# UNITED STATES PATENT AND TRADEMARK OFFICE

10/830,120

**Office Action Summary**

## **DETAILED ACTION**

**FIG.9d**

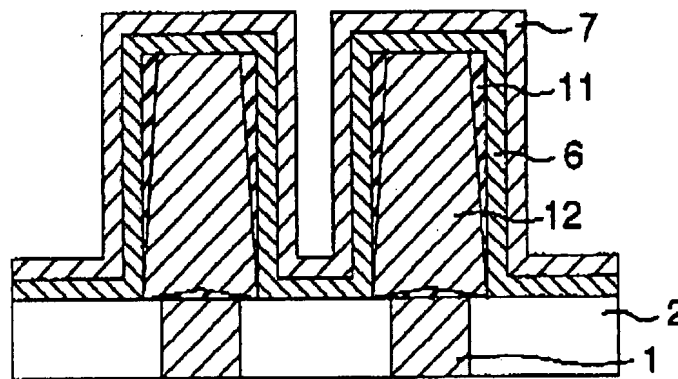
**Regarding claim 1, Matsui et al. discloses a stack-type capacitor comprising:**

a lower electrode (Matsui et al, Fig. 9d);

a dielectric layer formed on the lower electrode (Matsui et al, Fig. 9d);

and an upper electrode formed on the dielectric layer (Matsui et al, Fig. 9d);

a first metal layer having a cylindrical shape and defining a cylindrical space (Matsui et al, Fig. 9d); and

a second metal layer completely filling the cylindrical space defined by the first metal layer (Matsui et al, Fig. 9d).

a lower electrode (Matsui et al, Fig. 9d);  
a dielectric layer formed on the lower electrode (Matsui et al, Fig. 9d);  
and an upper electrode formed on the dielectric layer (Matsui et al, Fig. 9d);  
wherein the lower electrode includes:  
a first metal layer having a cylindrical shape and defining a cylindrical space (Matsui et al, Fig. 9d);  
a second metal layer completely filling the cylindrical space defined by the first metal layer (Matsui et al, Fig. 9d);

Fig. 2

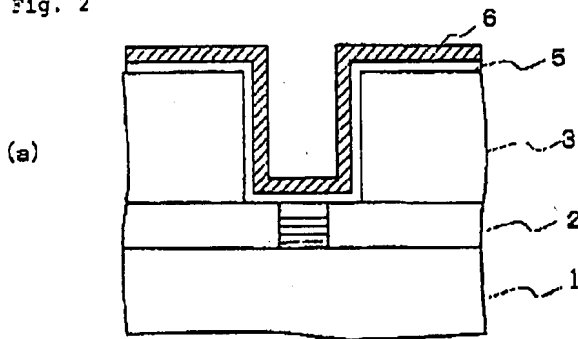
a lower electrode; (Aoki et al., Fig. 2 layers 5&6)

a dielectric layer formed on the lower electrode; (Aoki et al, Fig. 2 ref # 7)  
 and an upper electrode formed on the dielectric layer, (Aoki et al, Fig. 3 ref  
 # 8)

a first metal layer having a cylindrical shape and defining a  
 cylindrical space; and (Aoki et al, Fig. 2 ref # 6)

a lower electrode; (Aoki et al., Fig. 2 ref #'s 5&6)

a dielectric layer formed on the lower electrode; (Aoki et al., Fig. 2 ref # 7)

a first metal layer having a cylindrical shape and defining a cylindrical space; and (Aoki et al., Fig. 2 ref # 6)

Fig. 3

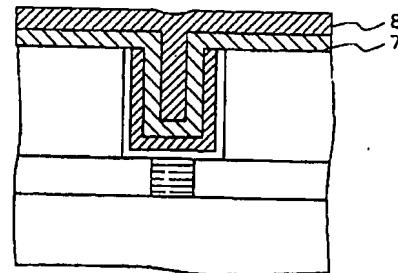
a second metal layer completely filling the cylindrical space defined  
 by the first metal layer (Aoki et al, Fig. 3 layer 6 completely fills in the top  
 surface of metal layer 5))

The shape of a capacitor's electrodes is merely a matter of design choice. The capacitance of a capacitor is proportional to the surface area of the conducting plate and inversely proportional to the distance between the plates. It is also proportional to the permittivity of the dielectric substance that separates the plates. The capacitance of a capacitor is given by:

and an upper electrode formed on the dielectric layer, (Aoki et al., Fig. 3 ref # 8)

a second metal layer completely filling the cylindrical space defined by the first metal layer (Aoki et al., Fig. 3 ref # 8)
